# Access Compliance Report

## Public Rights-of-Way

### (Curb Ramps)

Intersection ID: 52536	Main Street: VINOY_BV	Cross Street: IBM_DR	Location: SW
ADA ID: 3340BE8A0894	Ramp Type: PerpDiag	Initial Pass/Fail: Fail	Overall Compliance: No
		Severity Score: 35

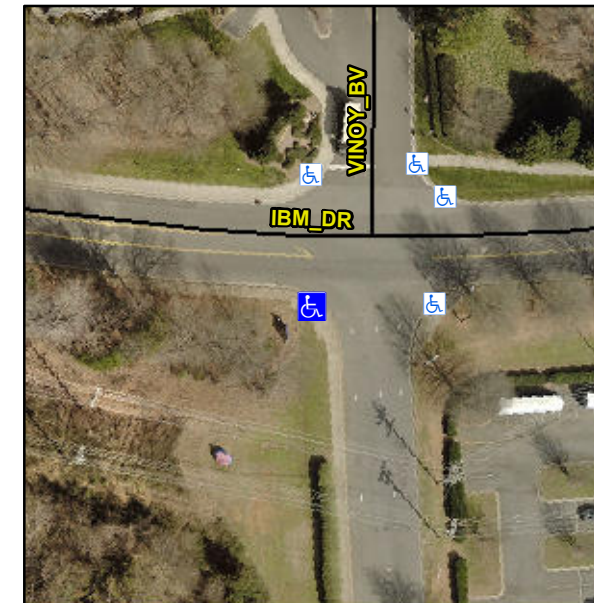
**Not Found, R304.5.1, R304.2.2, R304.5.3**

Compliance	Description	Data	Compliance	Description	Data
N/A	Ramp Length (in)	64.0	No	Ramp Slope (%)	12.6
No	Ramp Width (in)	40.0	No	Ramp XSlope (%)	2.3
N/A	Flare Type LT	N/A	N/A	Flare Type RT	N/A
N/A	Flare Slope LT (%)	N/A	N/A	Flare Slope RT (%)	N/A
N/A	Flare Traversable LT?	N/A	N/A	Flare Traversable RT?	N/A
N/A	Landing Length (in)	N/A	N/A	DWS Provided?	N/A
N/A	Landing Width (in)	N/A	N/A	DWS Contrast?	N/A
N/A	Landing Slope (%)	N/A	N/A	DWS Length (in)	N/A
N/A	Landing X Slope (%)	N/A	N/A	DWS Full Width?	N/A
N/A	Landing Curb? (Y/N)	N/A	N/A	DWS Offset (in)	N/A
N/A	Shared Landing?	N/A			
N/A	Gutter Ponding?	N/A	N/A	Gutter Slope (%)	N/A
N/A	Gutter Lip Ht (in)	1.5	N/A	Gutter X Slope (%)	N/A
N/A	Painted X Walk1?	No	N/A	Painted X Walk2?	No
	X Walk 1 Direction	To E		X Walk 2 Direction	To N
N/A	X Walk 1 Width (in)	N/A	N/A	X Walk 2 Width (in)	N/A
	X Walk 1 Slope (%)	4.2		X Walk 2 Slope (%)	2.2
	X Walk 1 X Slope (%)	0.5		X Walk 2 X Slope (%)	6.2

**Remove & Replace Curb Ramp With Two New Directional Ramps or Equivalent.**
